AGENDA
BOARD OF PUBLIC WORKS MEETING
Tuesday, June 28, 2022 at 6:00 p.m.
Jackson Municipal Complex
Village Board Room
N168W19851 Main Street
Jackson, WI 53037

From: [Pete Schau](#)
To: [Brian Kober](#)
Cc: [Jen Keller](#); barry.rogers@theaustin.com
Subject: RE: Jackson WT-W227 N16551 Cedar Parkway-VZW Fiber Add
Date: Thursday, June 23, 2022 1:30:42 PM
Attachments: [image001.png](#)
[VZW Node Conversion-Jackson WT-90% CD's 060222.pdf](#)

From: Pete Schau <petes@terraltd.com>
Sent: Friday, April 8, 2022 3:35 PM
To: Jen Keller <jen.keller@villageofjacksonwi.gov>; Brian Kober <brian.kober@villageofjacksonwi.gov>
Subject: Jackson WT-W227 N16551 Cedar Parkway-VZW Fiber Add

PROPOSED VERIZON FIBER INSTALLATION AT EXISTING VERIZON EQUIPMENT AREA.

1 LOCATION PLAN

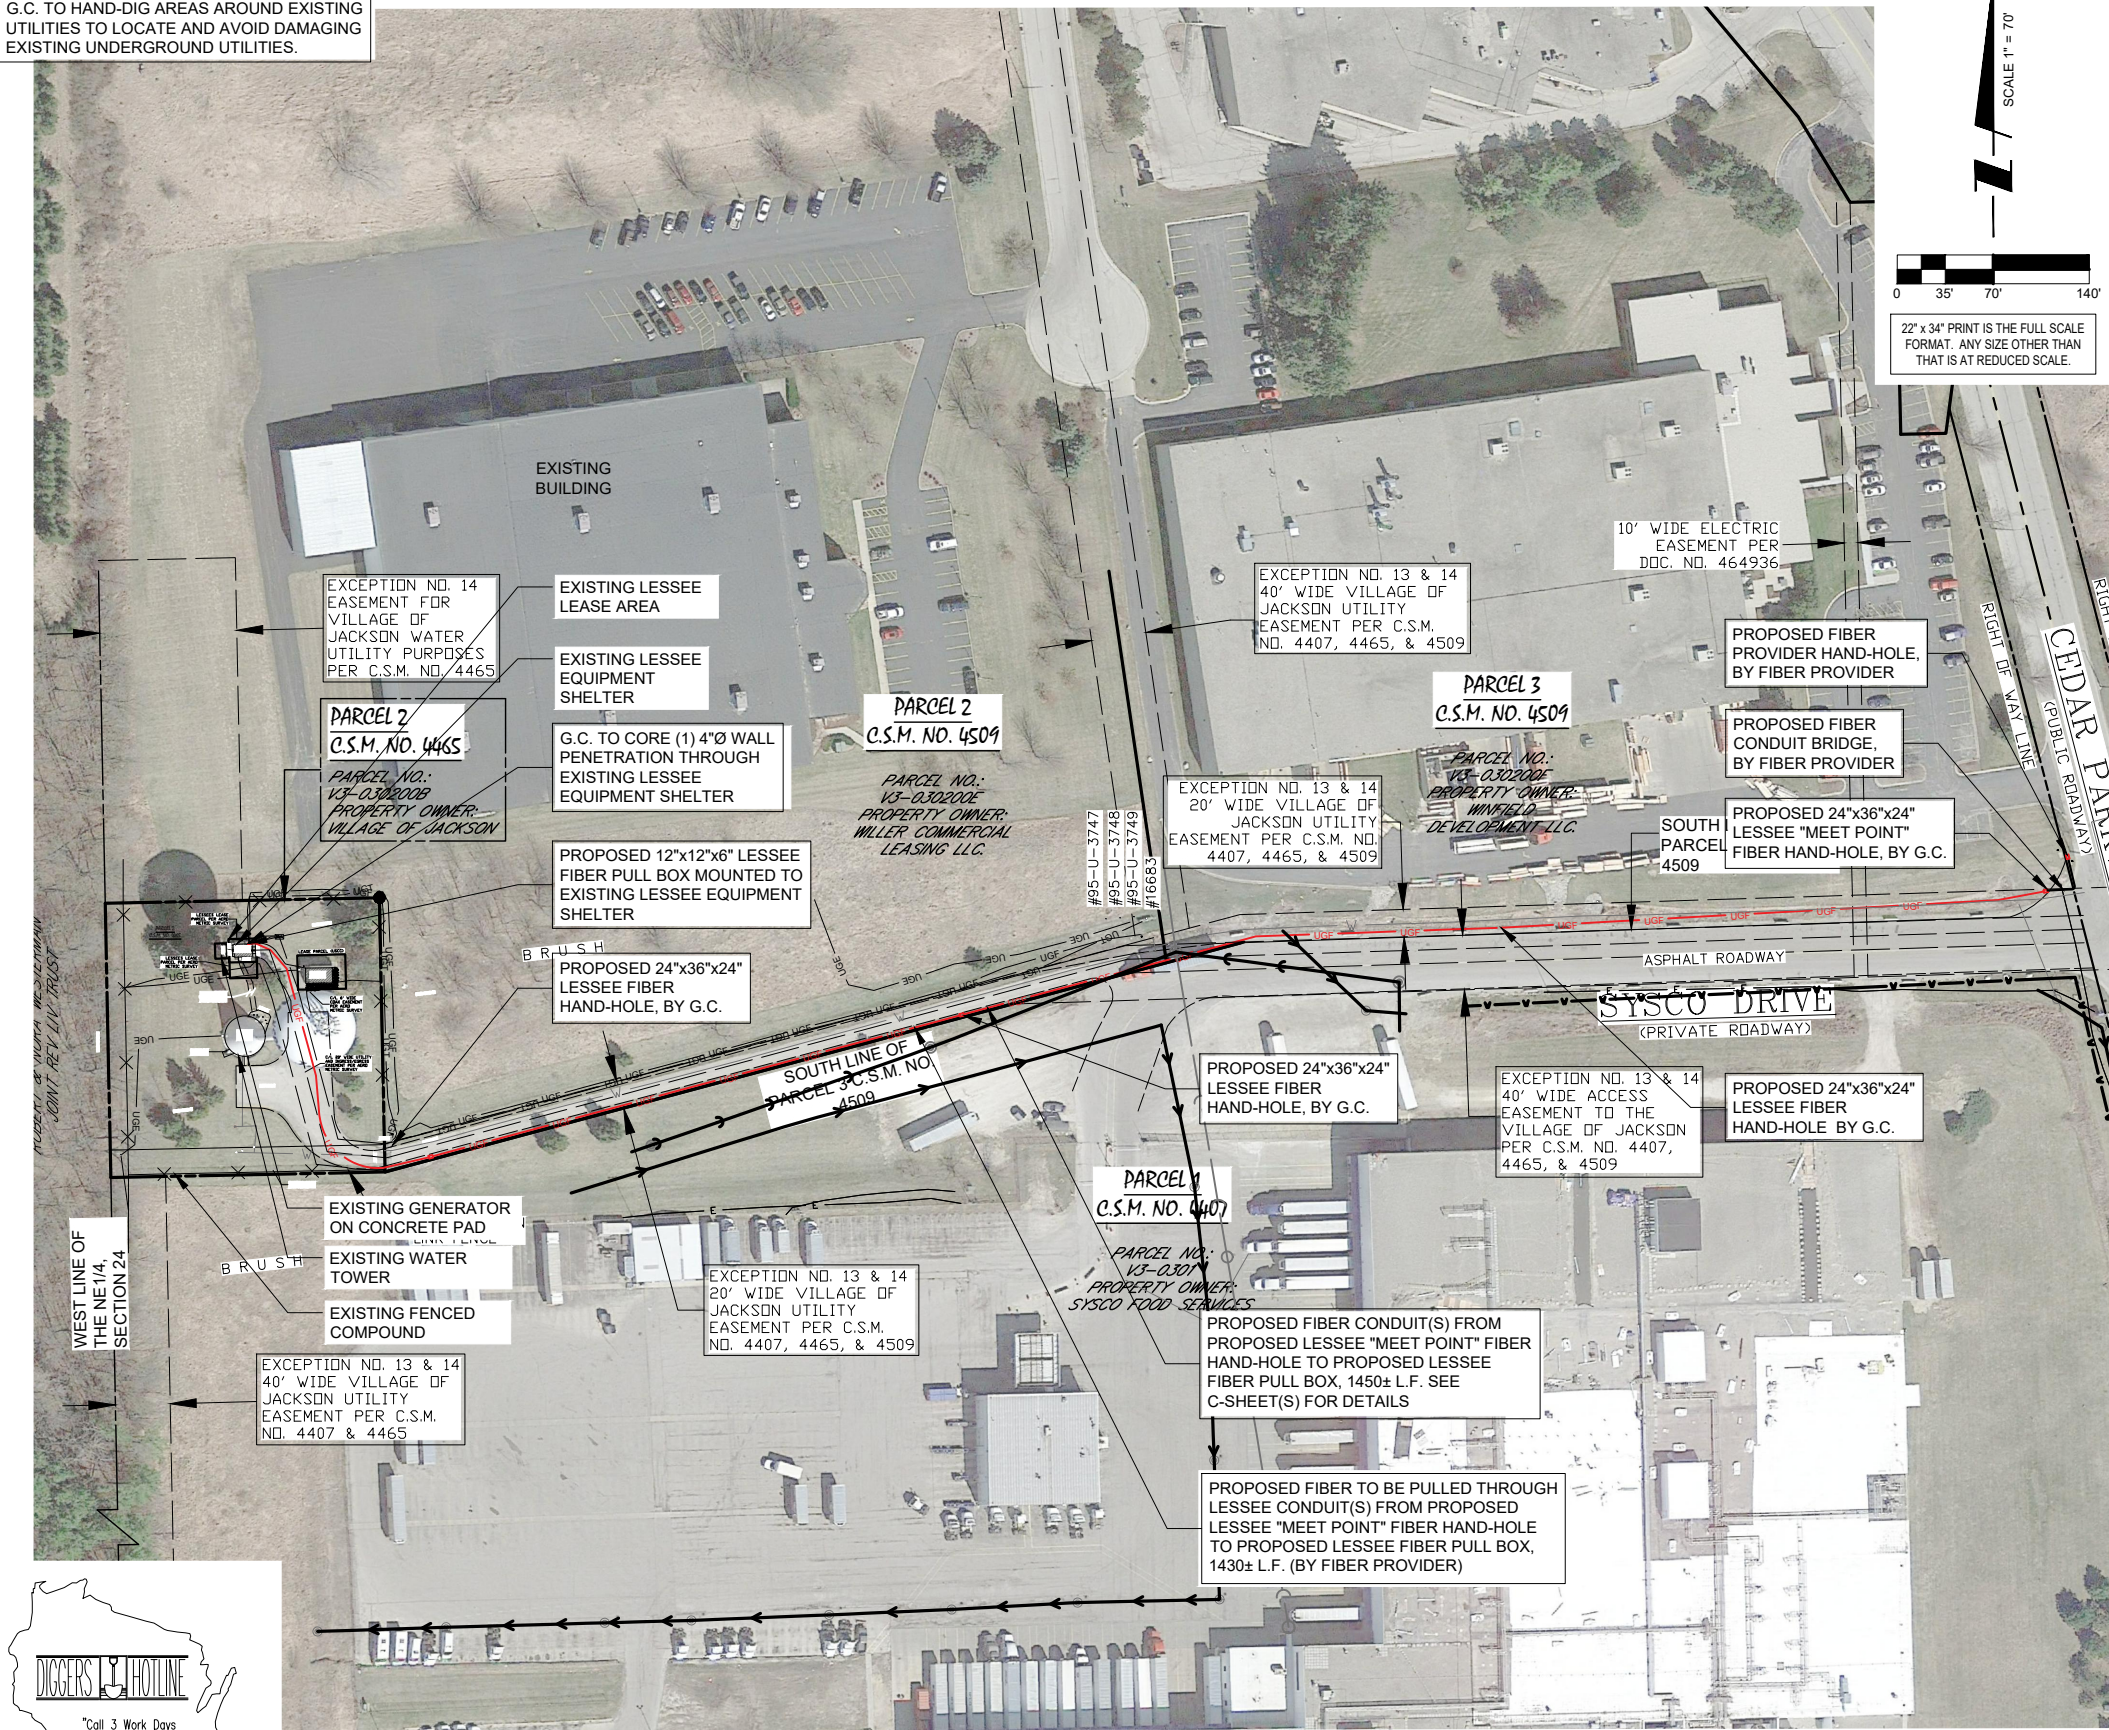
1. CSM 4465 has Twenty (20) foot Utility Easement current for Jackson Water Utility water main. We would like to keep the easement that way. Verizon has currently utility installed outside the easement serving the Verizon Equipment building. The Jackson Water will require to the same location outside the Jackson Utility Easement;
2. There is no existing twenty (20) foot Verizon on tower site per CSM 4465. Please provide recorded documentation showing the easement. Attached is file "Exhibit A" showing a new proposed route for your utility;
3. The Agreement will need to reviewed for the new fiber line;
4. Also, attached is the proposed site plan for Sysco planned building expansion. Barry Rogers is the Lead Architect and Project Manager for Sysco. Mr. Rogers is copied on the email.

1. CSM 4465 has Twenty (20) foot Utility Easement current for Jackson Water Utility water main. We would like to keep the easement that way. Verizon has currently utility installed outside the easement serving the Verizon Equipment building. The Jackson Water will require to the same location outside the Jackson Utility Easement; **The existing Tower/Land Lease agreement is structured so that Verizon Wireless gains its ingress/egress and utility access through those leased easement locations depicted in the plan pages attached as Exhibit A to the lease. Those plan pages include the 20' W easement as shown in these fiber drawings and VZW cannot install its new conduits outside of those areas without obtaining separate**

easements with the owners of the two adjacent properties Parcel's 2 & 3 of CSM 4509. The existing facilities (Telco, Fiber, Electric) installed outside of those designated areas belong to the servicing utility provider which would have obtained the necessary approvals for their placement outside of the Verizon Wireless utility easements at the time of installation.

2. There is no existing twenty (20) foot Verizon on tower site per CSM 4465. Please provide recorded documentation showing the easement. Attached is file "Exhibit A" showing a new proposed route for your utility; Verizon's lease interest post dates CSM 4465 and it didn't record a memorandum of lease. Though the lease doesn't expressly prohibit it, it doesn't state that VZW has the right to do so either. This would lead me to suspect that it may have been the preference of the Village at the time of the initial lease signing that a MOL was not recorded against the property by VZW, which is a common desire with municipal landlords. With this being said, the utility easement rights are conveyed to VZW under the lease agreement, not by plat, CSM, or a separate dedication.

3. The Agreement will need to be reviewed for the new fiber line; In addition to the provision in section 5(f) of the Tower/Land Lease I pointed to in the consent letter, attached is the file survey dated 1/16/97 with the VZW lease parcel ("A" & "B") locations for reference. This is the baseline drawing for the site plan page(s) attached as Exhibit "A" to the original Land Lease Agreement between the Village and Verizon Wireless. Also attached is a survey dated 4/4/08 which serves as Exhibit "A-1" to the (First) Amendment to Land Lease Agreement restating the Verizon Wireless lease premises and adding more room for the placement of the generator. The access and utility easement routes established in both are the same VZW is proposing to utilize for this fiber add. Hopefully these will assist the Village in its review of the agreement relative to the proposed fiber installation.

4. Also, attached is the proposed site plan for Sysco planned building expansion. Barry Rogers is the Lead Architect and Project Manager for Sysco. Mr. Rogers is copied on the email. I've sent this plan to the project engineer for review to make sure the proposed fiber route doesn't conflict with any underground utility locations on the Sysco expansion plan. Is there anything specific you would like addressed in the drawings, etc., relative to this plan? Otherwise, they don't anticipate any conflicts with the locations and note that the new fiber line will be directionally bored at a level beneath these lines.
